**NOTICE OF DECISION TO CONSENT TO CHANGE TO PROPOSAL DURING
ASSESSMENT**

Miralga Creek DSO Project
Assessment No. 2246

STATEMENT OF REASONS

Proposal: Miralga Creek DSO Project

Attachment 3: Changes to the proposal – Stockyards

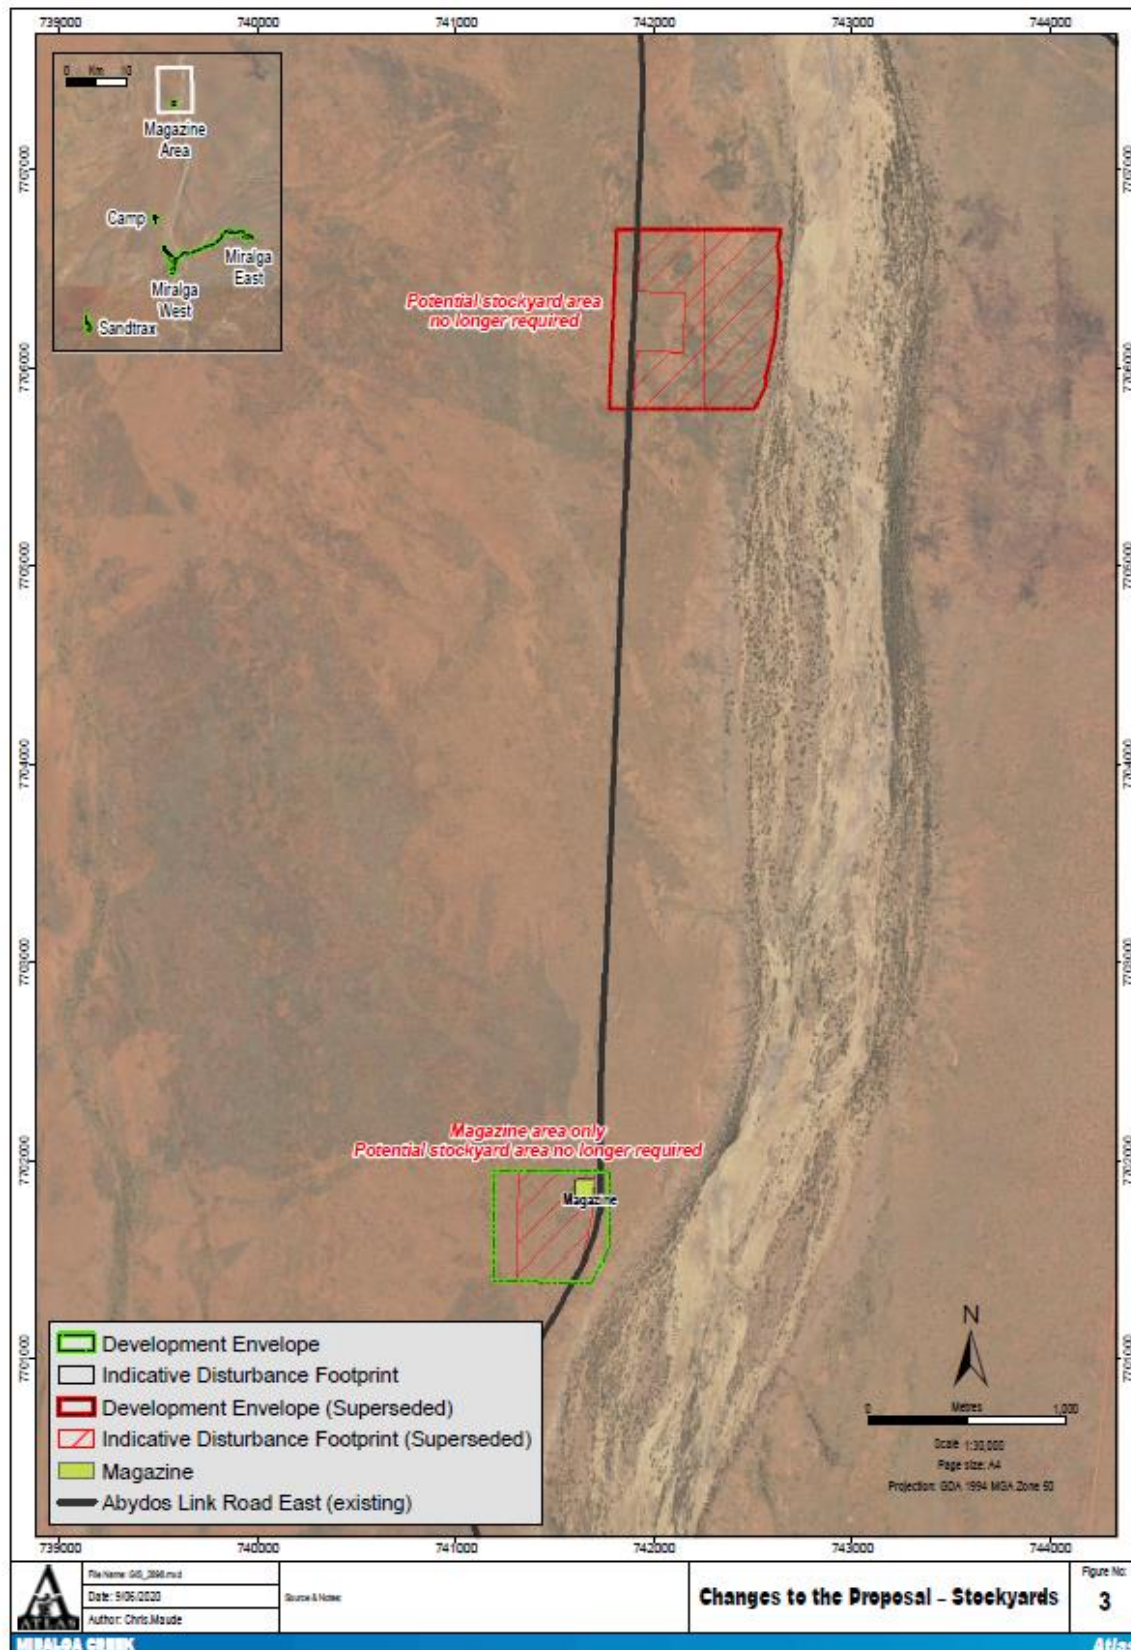
- Changes to the proposed operations mean these stockyards are no longer required. Product stockpiling will instead occur at Miralga West.
- The northern (larger) stockyard has been removed from the indicative disturbance footprint and development envelope. The southern (smaller) stockyard has been removed from the indicative disturbance footprint, however the explosives magazine has been retained and the development envelope is unchanged in this location as it aligns with the proponents underlying general purpose tenement G45/340.

Attachment 4: Changes to the proposal – Development envelope and indicative disturbance footprint

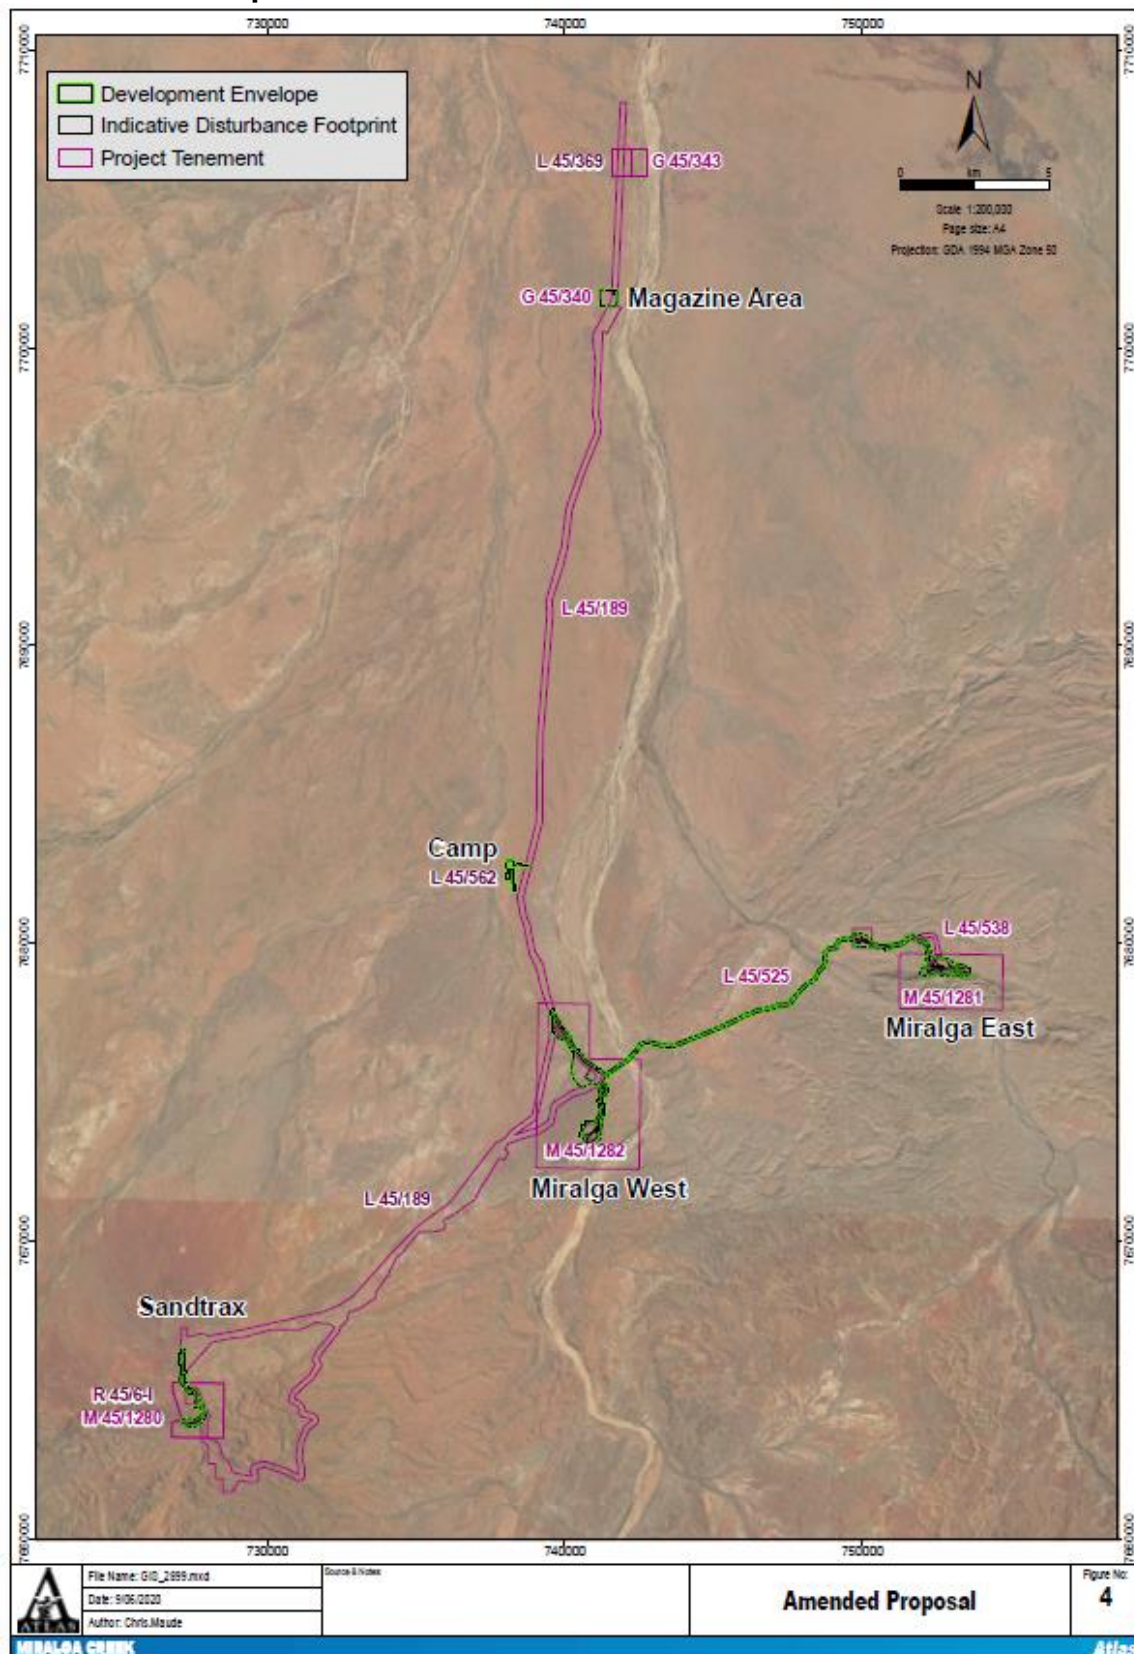
The proposed changes will result in an overall decrease in total area of the development envelope from 621.1 ha to 556.8 ha, compared to the original proposal this is a 64.3 ha (10 %) reduction. A reduction of clearing in the inductive disturbance footprint from 284.9 ha to 219.8 ha, compared to the original proposal this is a 65.1 (22 %).

Attachment 6: Changes to the proposal – Vertebrate fauna habitats

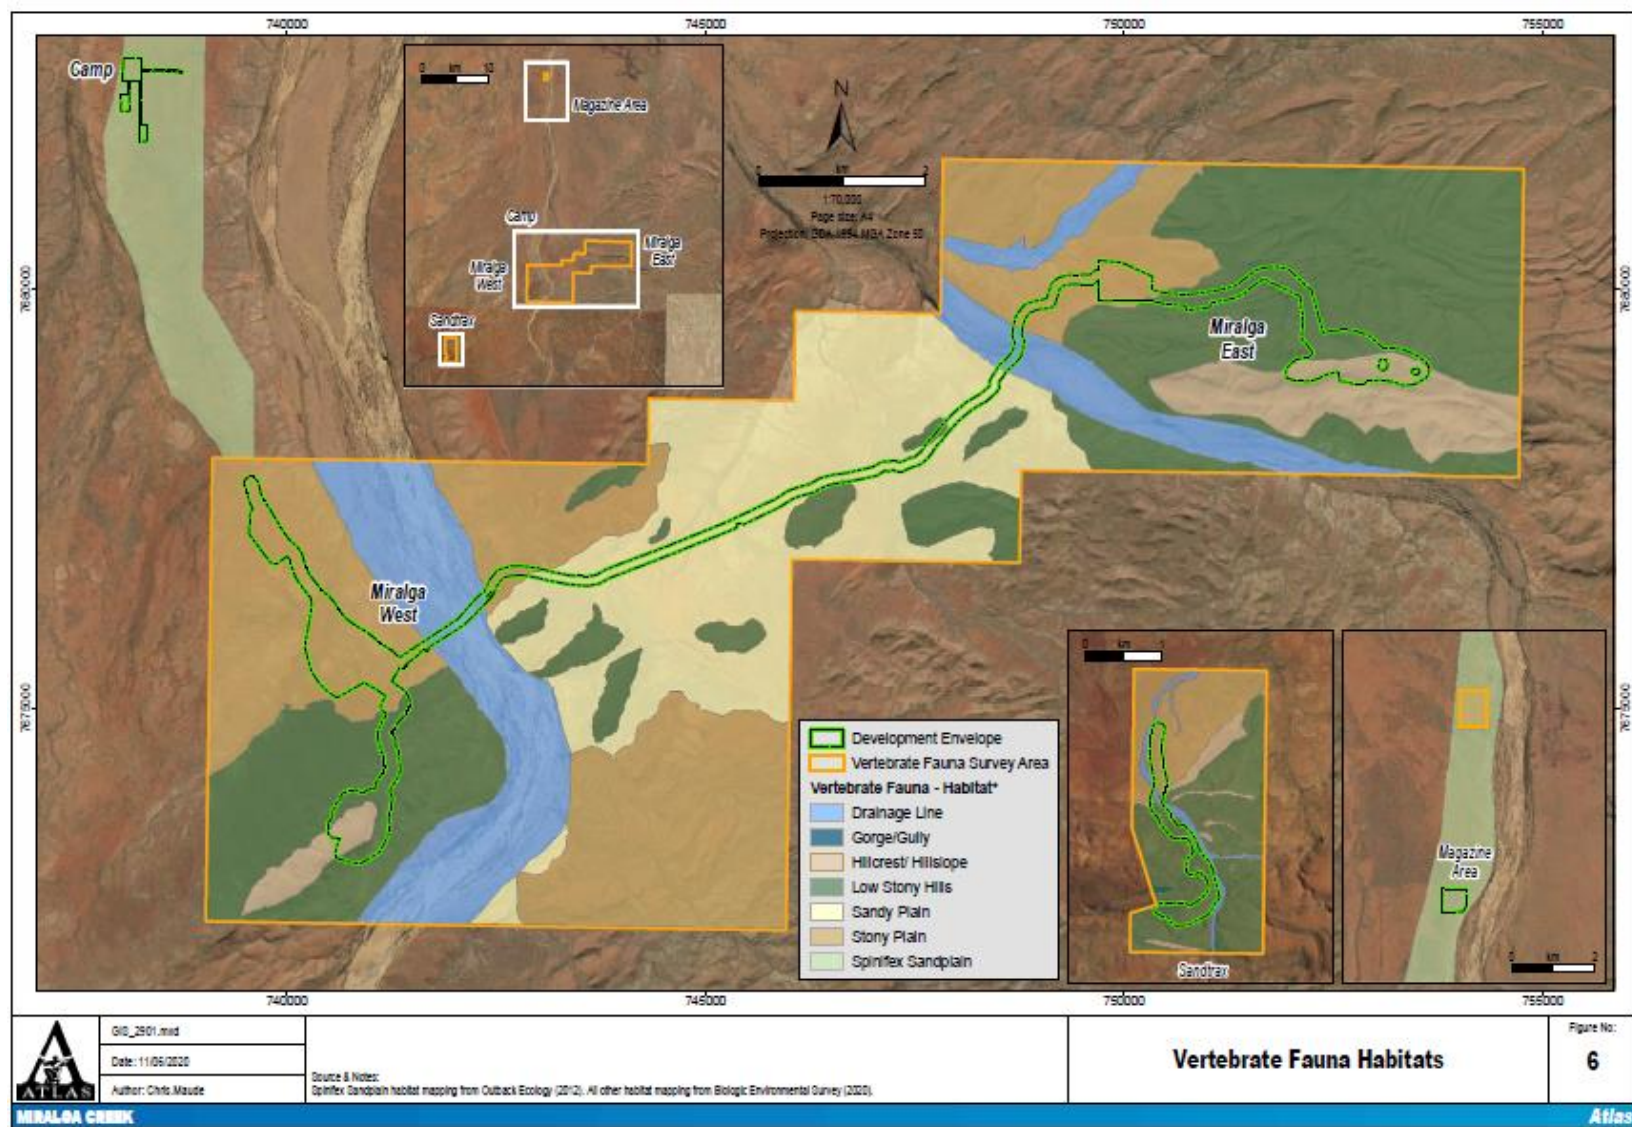
Impacts to most fauna habitat types will reduce or remain the same under the amended proposal except for major drainage and hillcrest/hillslope. Impacts to major drainage will increase from 19.6 ha to 19.8 ha (increase by 0.3 %). Impacts to hillcrest/hillslope will increase from 58.9 ha to 66.2 ha due to the relocation of the Miralga West WRD. This represents 15.4 % of the mapped area of hillcrest/hillslope habitat, up from 13.7 % in the original proposal. While this is an increase in impact to significant habitat used by conservation significant species, it is not likely to significantly increase the impact of the proposal on the environment after mitigations (including offsets) are applied.
